OPTION 1 COMMENTS

FRAMEWORK PLAN AFTER FULL BUILDOUT

OPTION 2 COMMENTS

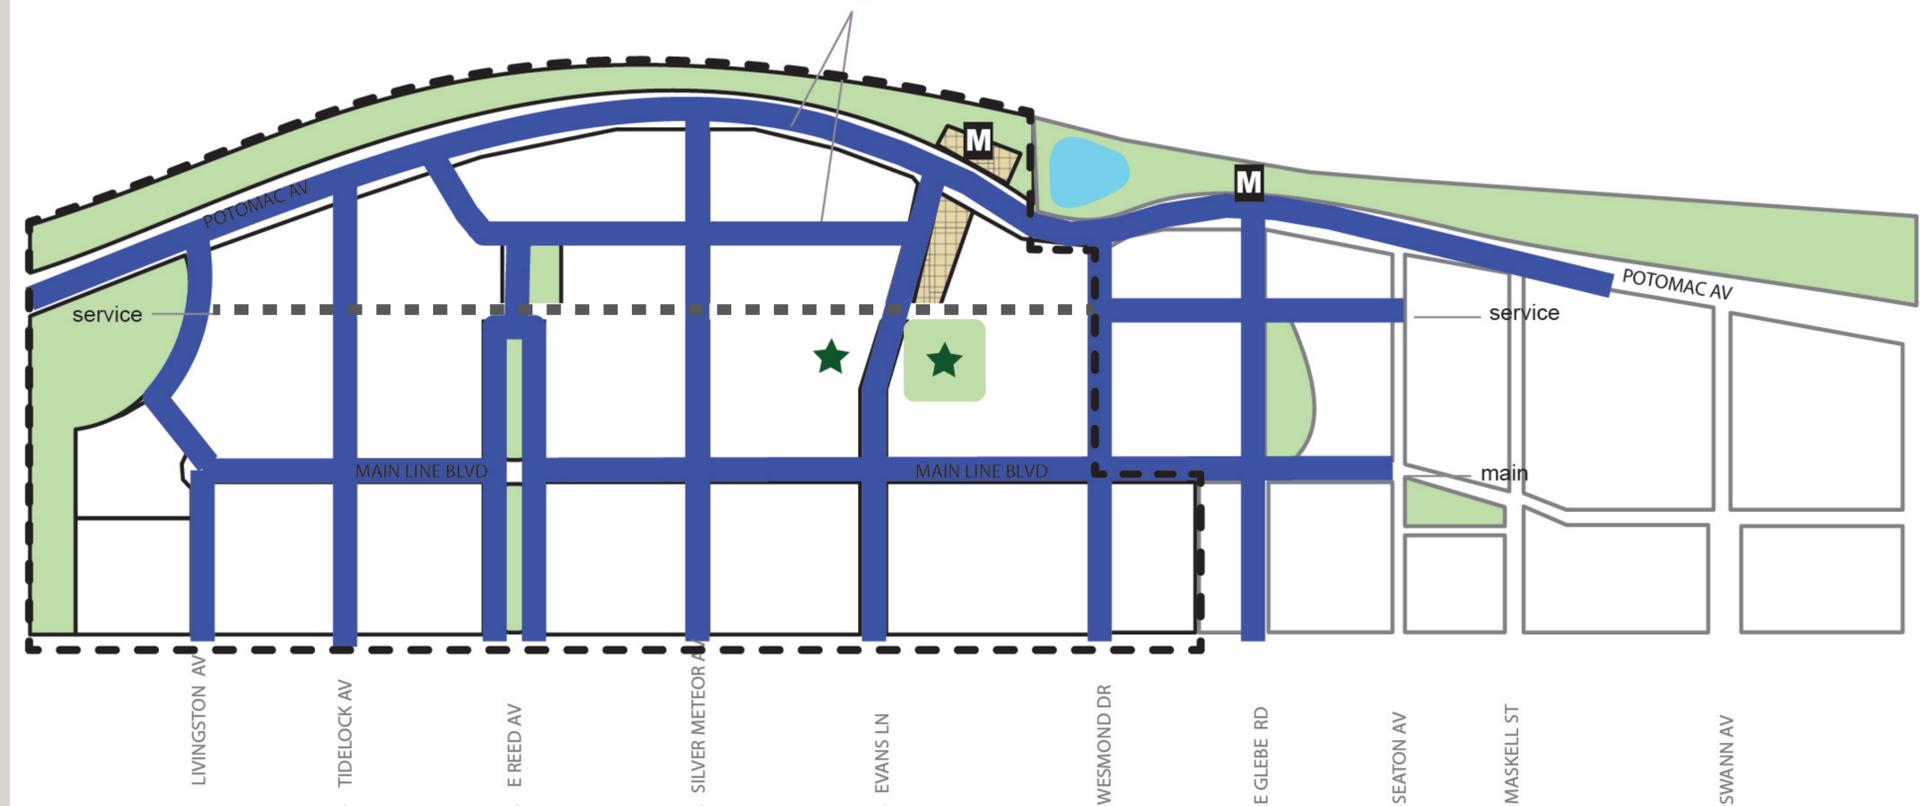
- Reducing width of Potomac Ave can improve pedestrian/transit experience of both
- Explore possibilities of Option 1 further to create destination for retail

- Option 1 better for transit – easier drop off for cars
- Pedestrian Environment (in Option 1), can explore options for improvement. Smaller blocks aren't necessarily better

- Don't like the concept of a loading alley in Option 1 – would prefer a skinny street, some loading dispersed might be okay, even on Park
- In Option 1, could explore Evans as the BRT stop

- Service alley in Option 1 doesn't make sense, doesn't seem like apples to apples. Also don't like long blocks created as a result
- Option 1 grid shouldn't depict the service alley as a different street classification

- Option 1 is the same as Option 2 in terms of connectivity
- Potomac Avenue and Potomac Yard Park have a symbiotic relationship in the 2010 Plan. Like the clear separation of public/private;

- In terms of transit and pedestrian, both options are equal
 - In terms of Metro Zone landing, Option 2 favorable

- Legitimate concern to cross very wide road at Metro in Option 1. However, the urban design/unique character of park/road continuity is a positive
- Option 1 feels less pedestrian friendly and more vehicular friendly.
- Option 1 eliminates most of the pedestrian positives by placing the Metro station, with its foot at a major road. This road would cut off integration of the Metro pavilion with the rest of the development and would isolate the park in this section as well.
- Option 1 gets BRT closer to the Metro station, but I do not see this as a guiding force here since, as I understand it, the purpose of BRT is to get from point to point and not necessarily to get to a Metro station for further transit. Option 1 also gets local bus circulation a bit closer, but, again, I think pedestrian safety and walkability trumps both BRT and local bus circulation.

FRAMEWORK PLAN AFTER FULL BUILDOUT

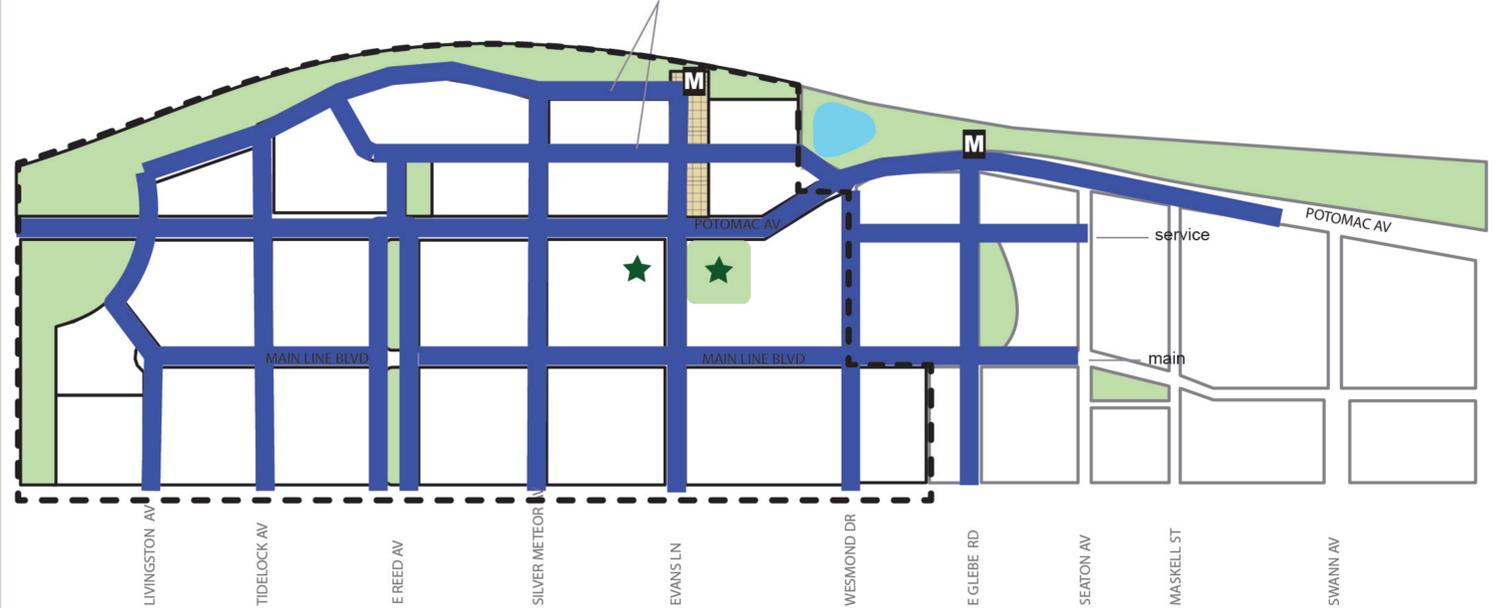
- Option 2 provides better pedestrian environment (e.g. smaller blocks for pedestrians, more inviting)... concerned about Metro across Potomac Avenue in Option 1

- Need more info in order to evaluate transit circulation
- Because of smaller blocks in Option 2 and more opportunity for pedestrians/bikes, is better option for achieving 2010 vision

- In Option 2 – prefer not to have a through-road around Metro
- Option 2 – like the street grid/connectivity – options for pedestrians/vehicles/transit, more flexibility to work with

- Don't like idea of bus drop off in front of hotel/retail, because of the idling impact
- Like the angled street/jog of Wesmond
- Like BRT serving more in Option 2

- Pedestrian access – favorably inclined to Option 2 – better by a little bit particularly because of Metro crossing/BRT
- Like Option 2 better, where the Metro lands is the most important. Pedestrians can immediately disperse, whereas in Option 1, bottleneck to cross street

- BRT serving retail street and as an alternative to Metro is better for Option 2
- Like Option 2 for integrated transit, stacked BRT, local, Metro seems like it will be effective mix

- In terms of Metro Zone landing, Option 2 favorable
- Option 2 offers more flexibility from a connectivity standpoint
- Existing residential areas east of Route 1 and access to NPY – don't like the many wide roads to cross

- Would prefer Option 2 with more of focus on pedestrian/bike access and connectivity
- BRT width is a concern for both Option 1 and 2. Phasing has a major impact so that Option 2 provides more flexibility in determining the final width needed for the BRT.

- I like how Option 2 immediately provides access to open space and destinations (future retail, residential, hotel, office) while the BRT is visible from the Metro entrance/exit. I prefer that we have a more vibrant experience at the entrance/exit than the alternative which is to cross multiple lanes of traffic. If one wants to cross multiple lanes of traffic, use the southern entrance/exit of the future Potomac Yard Metro.

- Both Options can score well in this category in terms of accommodating an integrated transit system (Metro, BRT, and local bus circulation). When pressed to choose, I choose Option 2. I like how the BRT is closer to the middle of the planned development area as depicted on the Option 2 Framework Plan.
